December 30, 1985
(NMP2L 0569)

Re: Nine Mile Point Unit 2
Docket No. 50-410

Enclosed is our marked-up copy of the "proof and review" version of the Technical Specifications, which we received from you on November 22, 1985 (Attachment A). This marked-up copy reflects our comments based on our review against the current plant design. Justification for proposed Technical Specification changes is provided in Attachment B, which also contains additional comments and clarifications, and several additional pages which should be incorporated into the Technical Specifications. Attachment C identifies the changes in Amendment 23 of the Final Safety analysis Report which affect the Technical Specifications.

SINGLE LOOP OPERATION
PROPOSED TECHNICAL SPECIFICATION CHANGES

FIGURE 3.4.1.1-1
THERMAL POWER VERSUS CORE FLOW

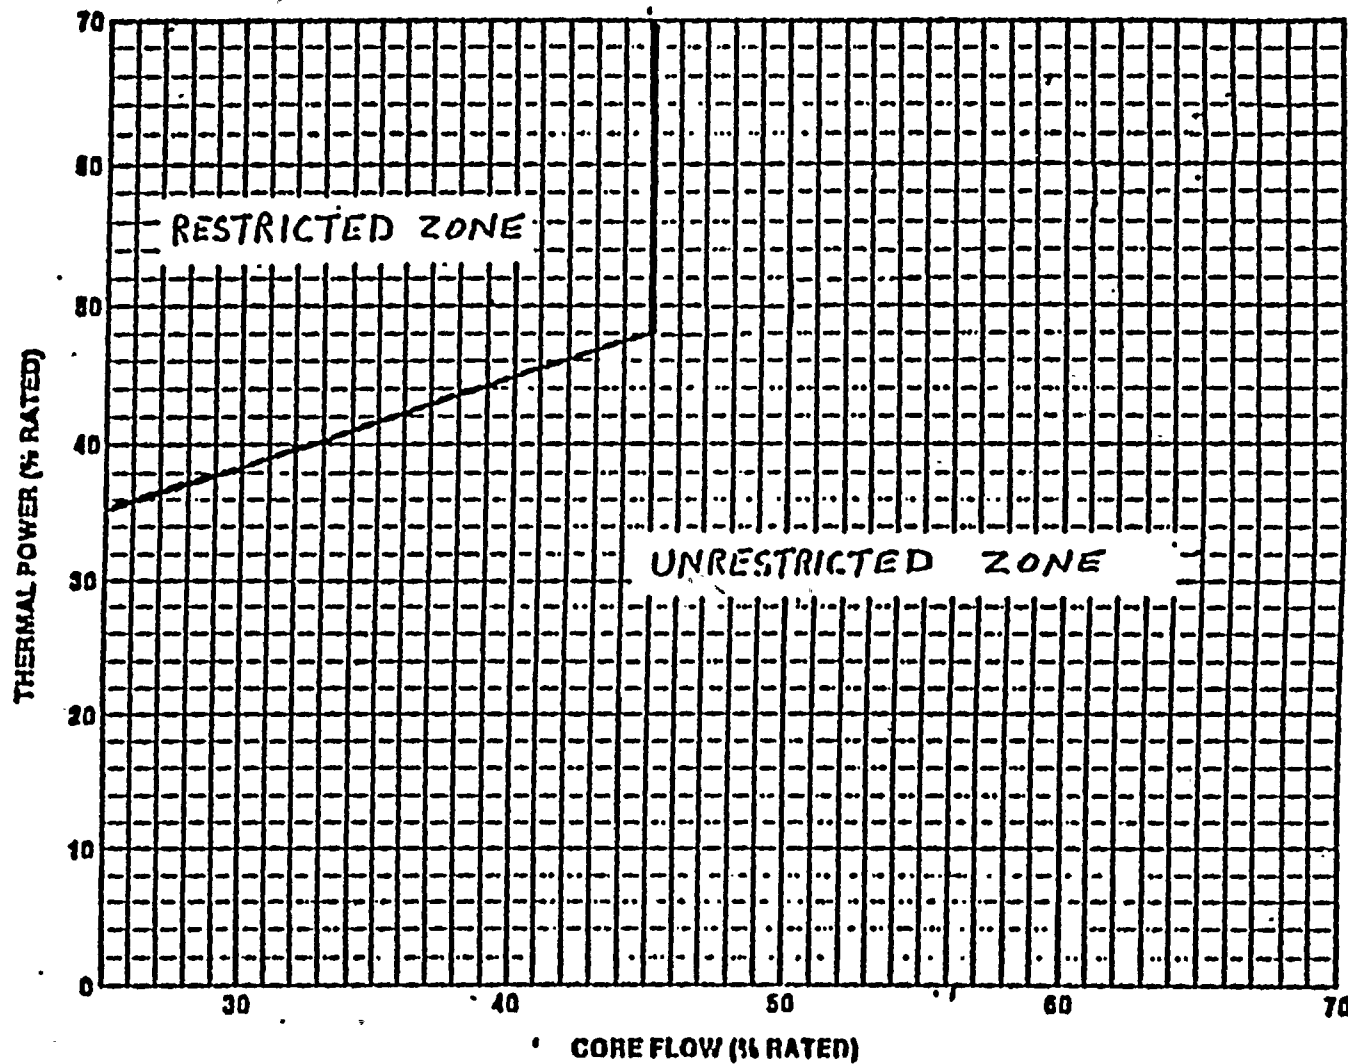
- a. Total core flow greater than or equal to 45% of rated core flow, or
- b. THERMAL POWER within the unrestricted zone of Figure 3.4.1.1-1.

- h) Determine that the reactor THERMAL POWER level is not within the restricted zone of Figure 3.4.1.1-1; otherwise, reduce the THERMAL POWER level or increase core flow.

- c. With two reactor coolant system recirculation loops in operation and total core flow less than 45% of rated core flow and THERMAL POWER greater than the limit specified in Figure 3.4.1.1-1:

- 2. With the APRM or LPRM** neutron flux noise levels greater than three times their established baseline noise levels, immediately initiate corrective action to restore the noise levels within the required limits within two hours by increasing core flow to greater than 45% of rated core flow or by reducing THERMAL POWER so that it is not within the restricted zone of Figure 3.4.1.1-1.

FIGURE 3.2.3-1 MINIMUM CRITICAL POWER RATIO, MCPR, vs TAU AT RATED FLOW

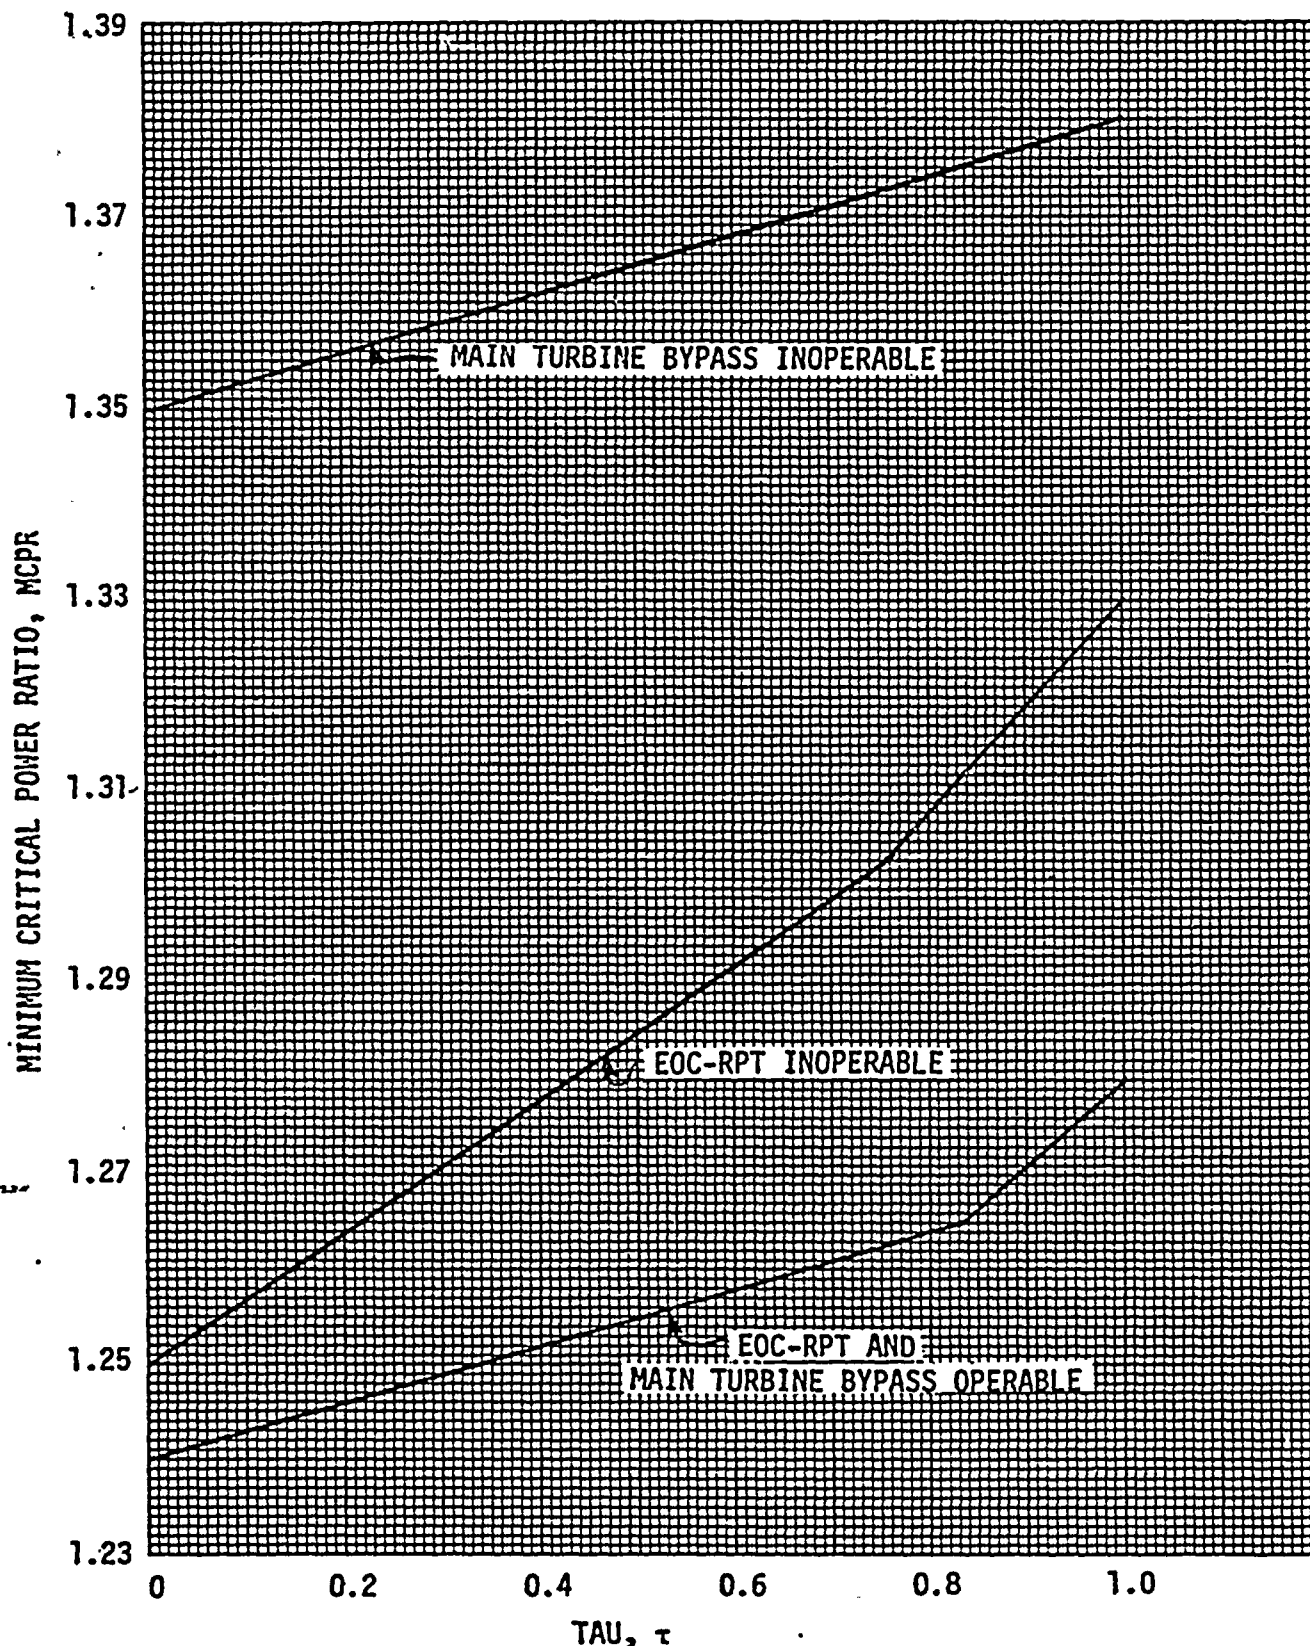
3.2.3 The MINIMUM CRITICAL POWER RATIO (MCPR) shall be equal to or greater than the MCPR limit shown in Figure 3.2.3-1 times the K_f shown in Figure 3.2.3-2 with:

- a. With the end-of-cycle recirculation pump trip system inoperable per Specification 3.3.4.2, operation may continue and the provisions of Specification 3.0.4 are not applicable provided that, within one hour, MCPR is determined to be equal to or greater than the MCPR limit shown in Figure 3.2.3-1 EOC-RPT inoperable curve, times the K_f shown in Figure 3.2.3-2.

- b. With the main turbine bypass system inoperable per Specification 3.7.8, operation may continue and the provisions of Specification 3.0.4 are not applicable provided that, within one hour, MCPR is determined to be equal to or greater than the MCPR limit shown in Figure 3.2.3-1, main turbine bypass inoperable curve times the K_f shown in Figure 3.2.3-2.

FIGURE 2.2.2. K_f AS A FUNCTION OF PERCENT CORE FLOW

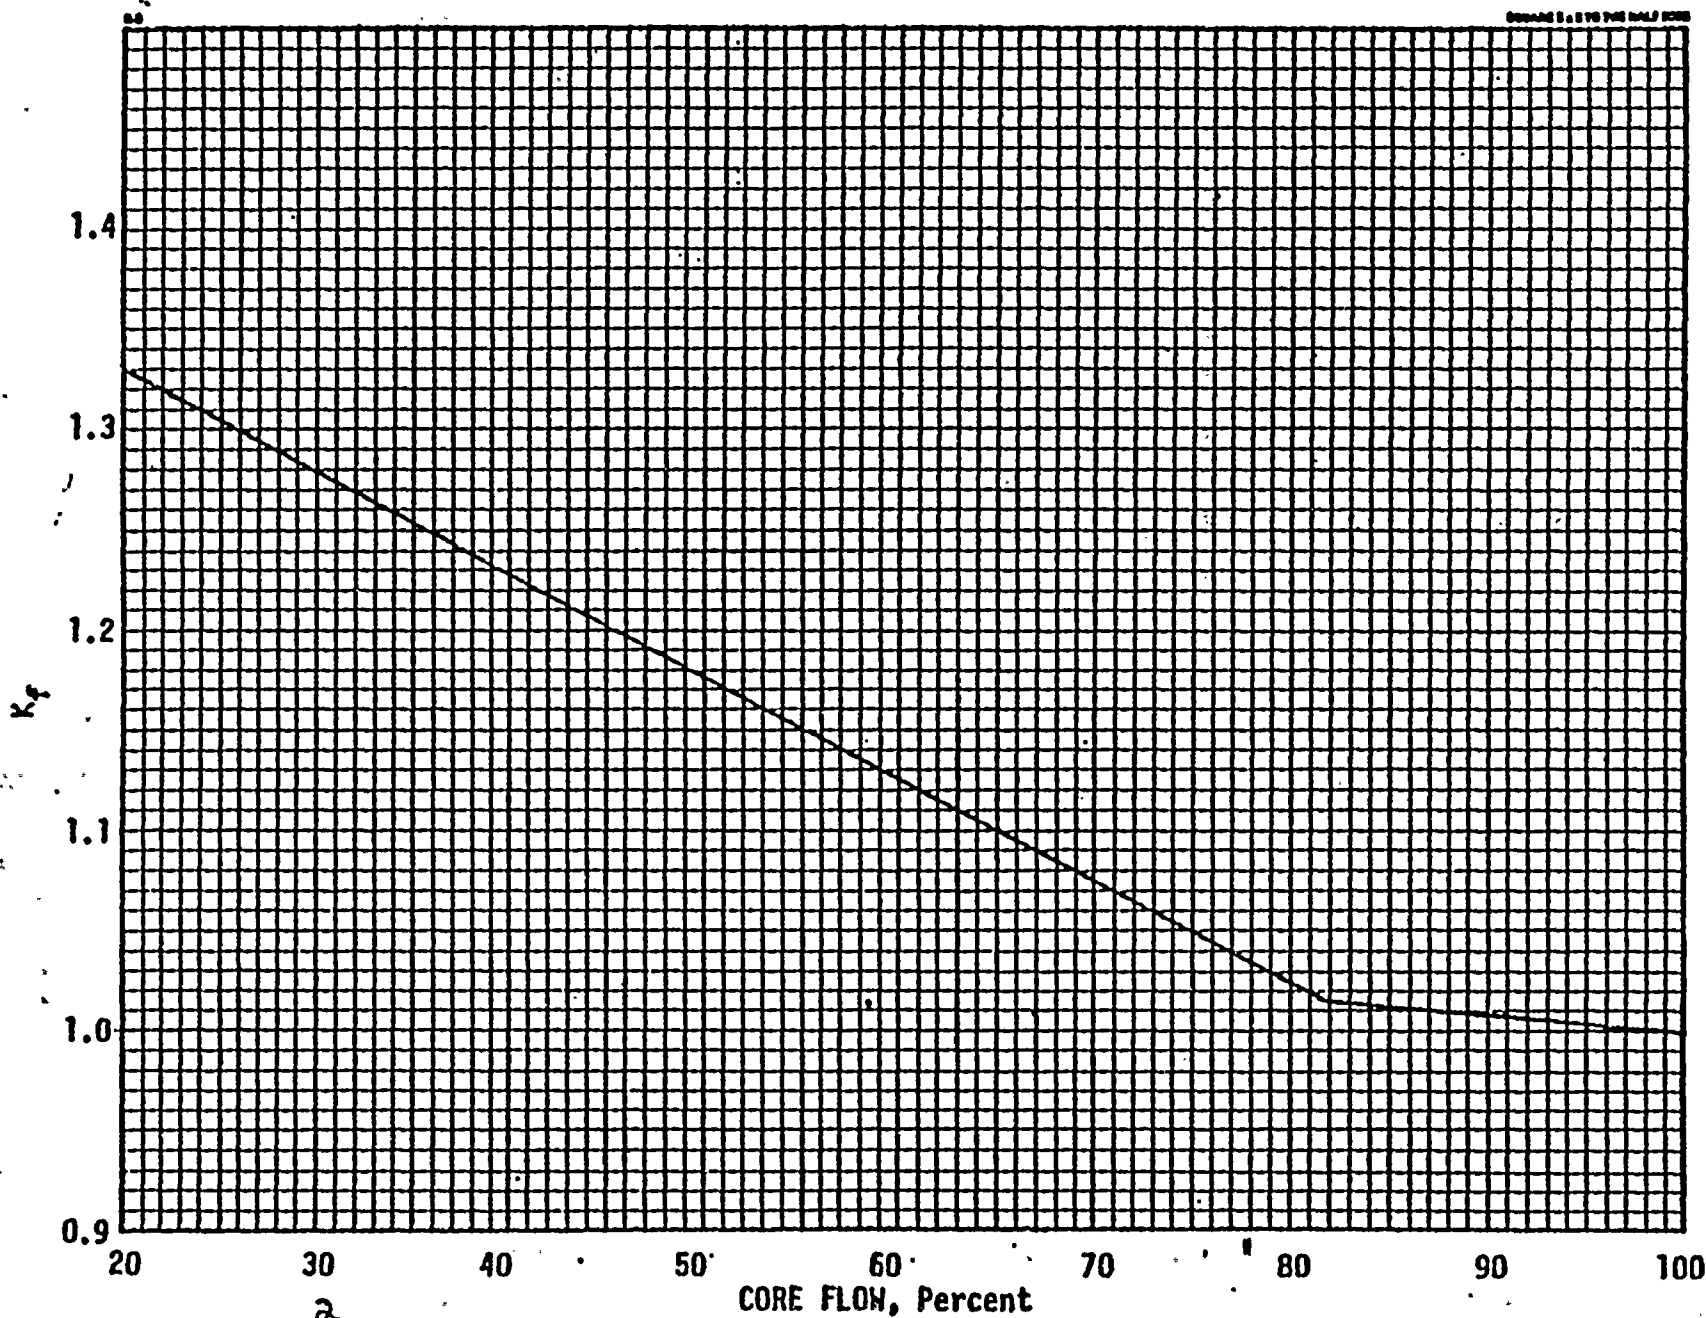
The purpose of the K_f factor of Figure 3.2.3-2 is to define operating limits at other than rated core flow conditions. At less than 100% of rated flow the required MCPR is the product of the MCPR and the K_f factor. The K_f factors assure that the Safety Limit MCPR will not be violated. The K_f factors were derived using THERMAL POWER and core flow corresponding to 105% of rated steam flow.

FIGURE 3.2.3-1 K_f AS A FUNCTION OF PERCENT CORE FLOW

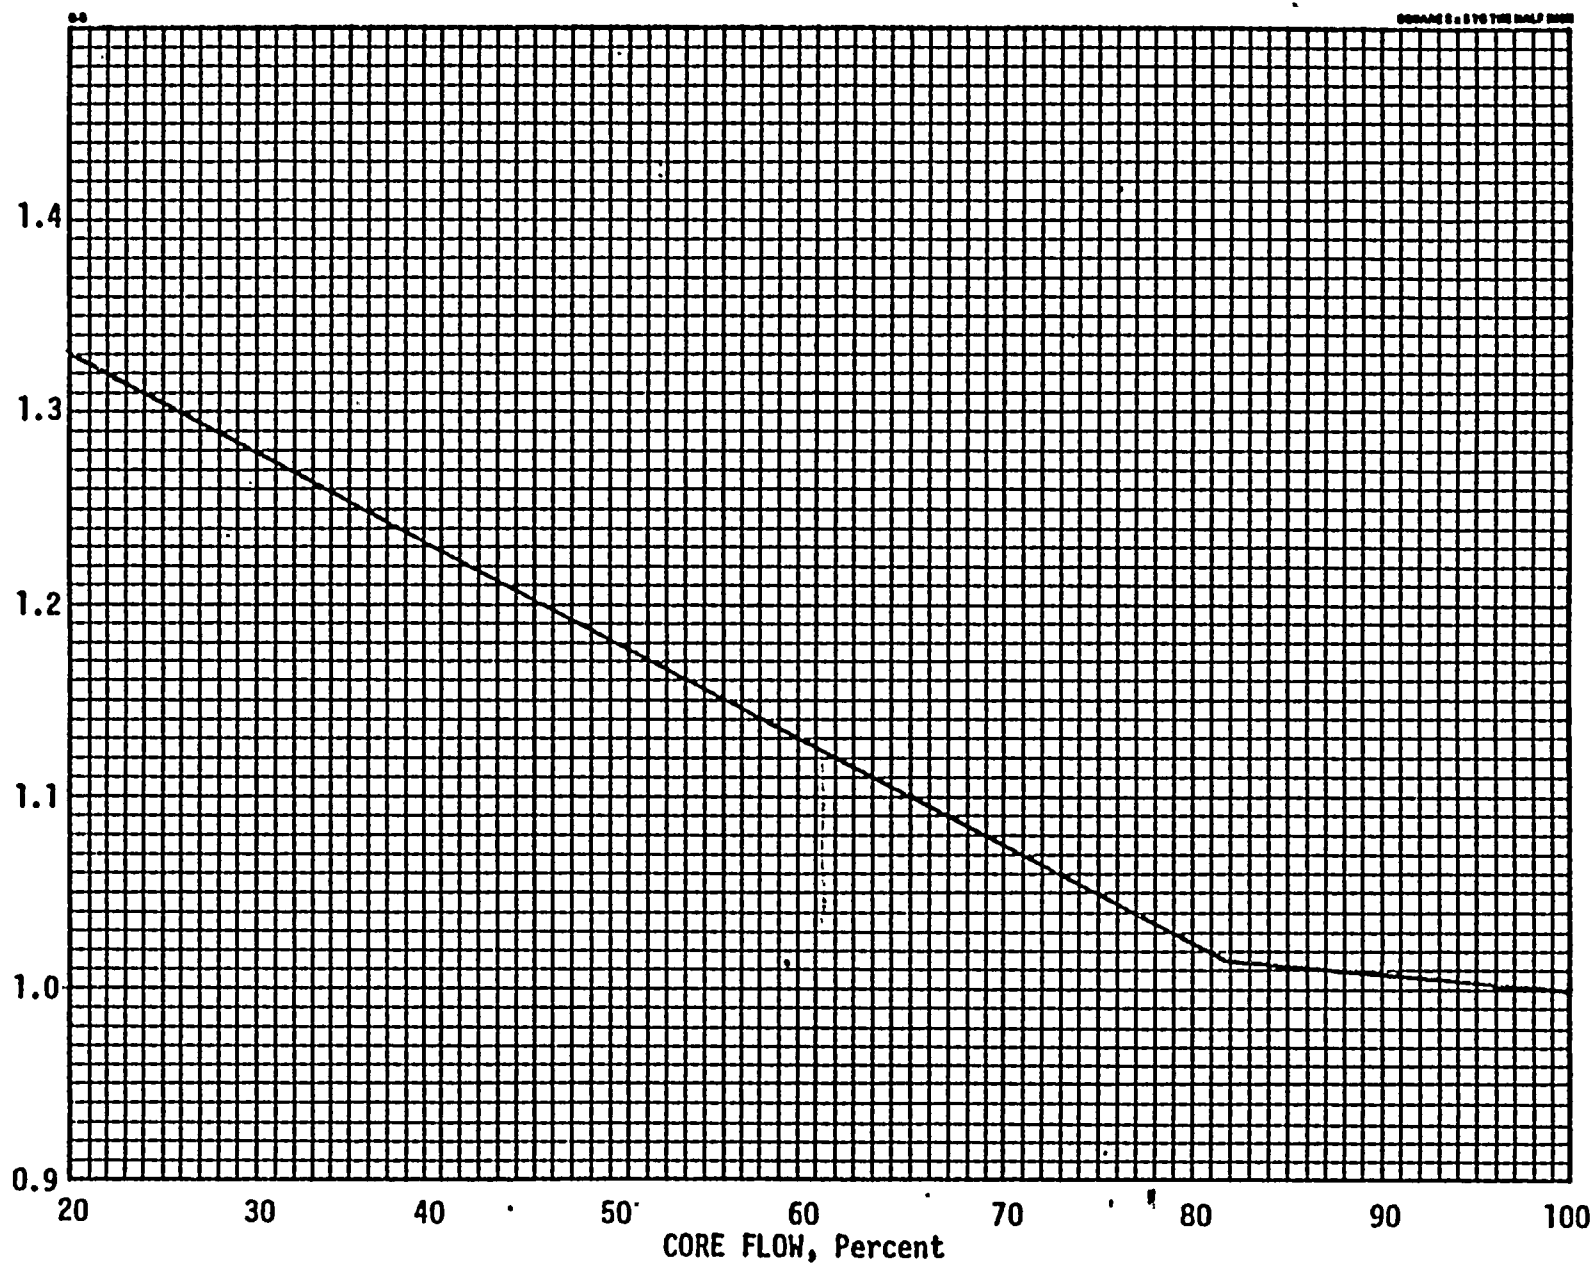
~~The K_f factors shown in Figure 3.2.3-1 are conservative for the General Electric plant operation because the operating limit MCPRs of Specification 3.2.3 are greater than the original 1.20 operating limit MCPR used for the generic derivation of K_f .~~

FIGURE B 3/4 4.6-1 FAST NEUTRON FLUENCE (E>1 Mev)
AT 1/4 T AS A FUNCTION OF SERVICE LIFE*

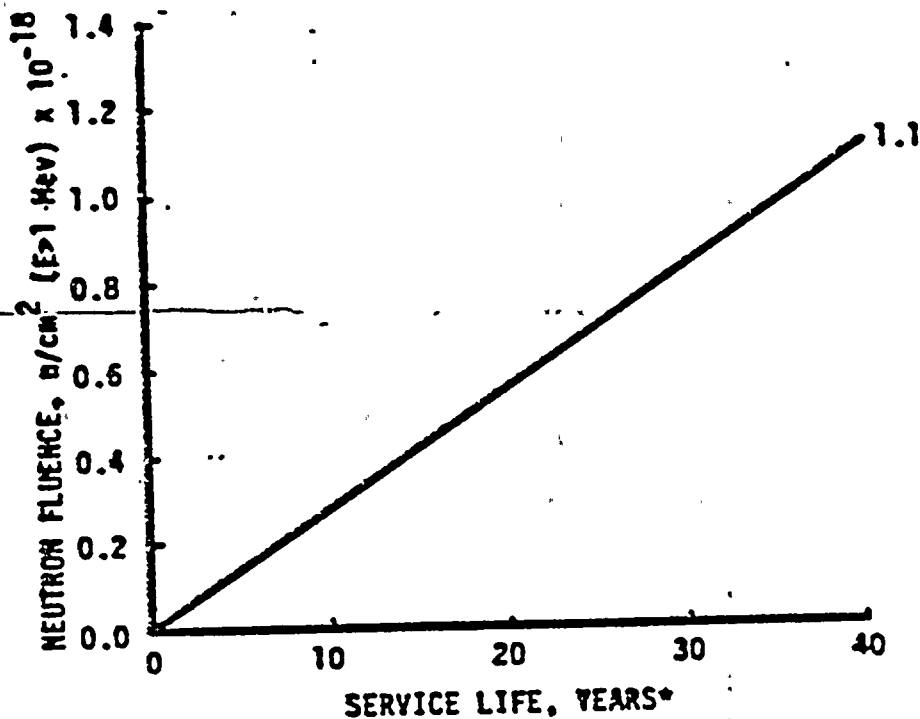
The reactor vessel materials have been tested to determine their initial RT_{NDT}. The results of these tests are shown in ^{Table} Figure B 3/4.4.6-1. Reactor operation and resultant fast neutron, E greater than 1 MeV, irradiation will cause an increase in the RT_{NDT}. Therefore, an adjusted reference temperature, based upon the fluence, phosphorus content and copper content of the material in question, can be predicted using Bases Figure B 3/4.4.6-1 and the recommendations of Regulatory Guide 1.99, Revision 1, "Effects of Residual Elements on Predicted Radiation Damage to Reactor Vessel Materials."

The actual shift in RT_{NDT} of the vessel material will be established ^{specimens} periodically during operation by removing and evaluating, irradiated ~~flux wires~~ installed near the inside wall of the reactor vessel in the core area since the neutron spectra at the ~~flux wires~~ ^{specimens} and vessel inside radius are essentially identical. The irradiated ~~flux wires~~ ^{specimens} can be used with confidence in predicting reactor vessel material transition temperature shift. The operating limit curves of Figure 3.4.6.1-1, 3.4.6.1-2 and 3.4.6.1-3 shall be adjusted, as required, on the basis of the specimen data and recommendations of Regulatory Guide 1.99, Revision 1. ^{Data determined from flux wires removed at the end of the first cycle will be used to adjust the fluence of Figure B 3/4.4.6-1.}
